ATA Overlap Proposal

This document presents the detailed text changes to the ATA-3 document (X3T10/2008Dr6) for the Overlap proposal. It is based on the Overlap proposal submitted by Western Digital Corporation (X3T10/95-258r0) with the changes presented by Quantum Corporation (X3T10/95-257r0).

Figure xx - Selection of device with pending interrupt

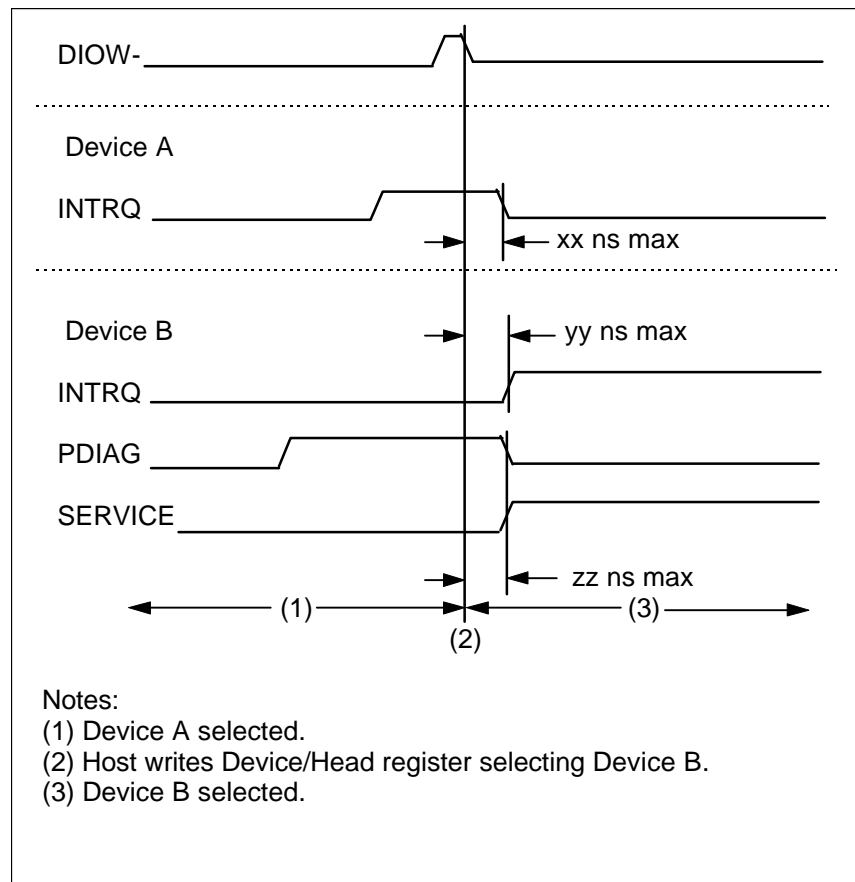
When the Device/Head register is written to select the device with the interrupt pending, the previously selected device shall cease asserting INTRQ within ns. The newly selected device shall set SERVICE, assert INTRQ and negate PDIAG no sooner than ns after the receipt of the SERVICE command but no later than ns. It is possible that the host will see INTRQ negate then reassert. See figure xx.

Figure yy Deselection of device with pending interrupt

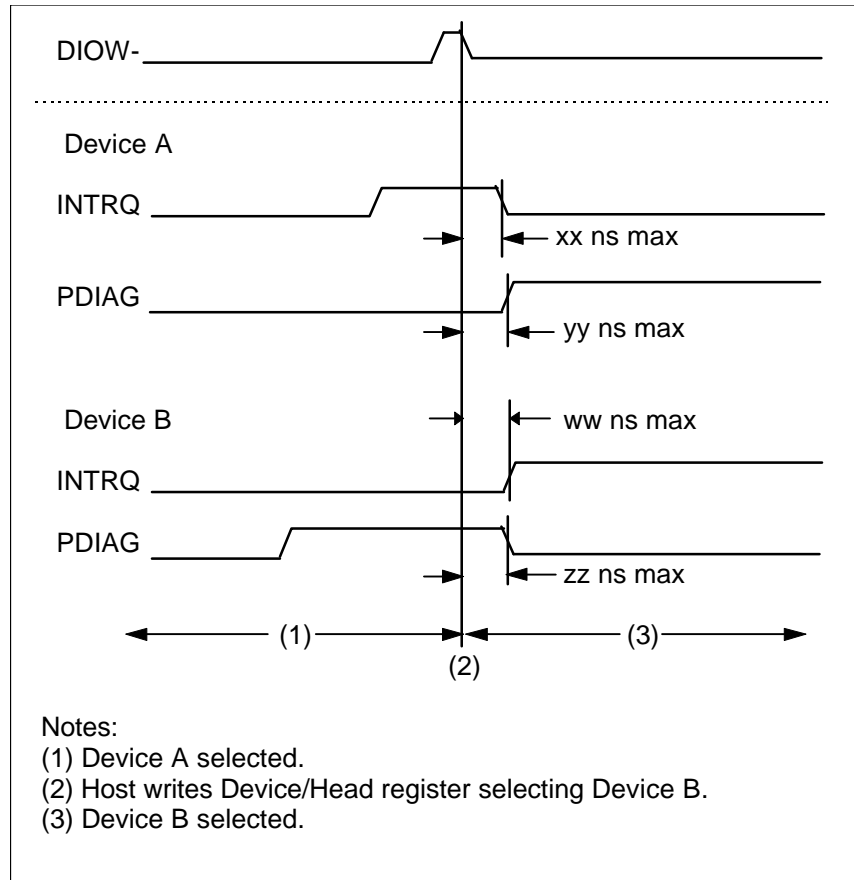
When a selected device has a pending interrupt and INTRQ asserted, if the other device is selected by writing to the Device/Head register, the device shall negate INTRQ within x ns and assert PDIAG- within y ns. If the newly selected device has an interrupt pending and was asserting PDIAG-, the newly selected device shall negate PDIAG- within z ns and assert INTRQ within w ns. See figure yy.

Figure zz - Proxy interrupt following selected device interrupt

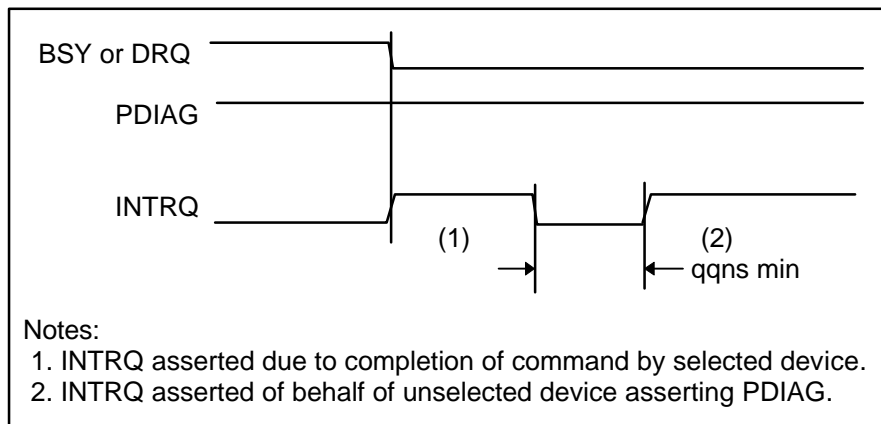
If a selected device is busy executing a command, i.e., BSY or DRQ set, when the unselected device asserts PDIAG, the selected device shall not assert INTRQ until it is no longer busy. When the selected device completes its command, it may assert INTRQ on its own behalf to indicate the command completion. In this case, the selected device shall not assert INTRQ on behalf of the unselected device until qqns after INTRQ has been negated when the selected device interrupt pending is cleared. See figure zz.
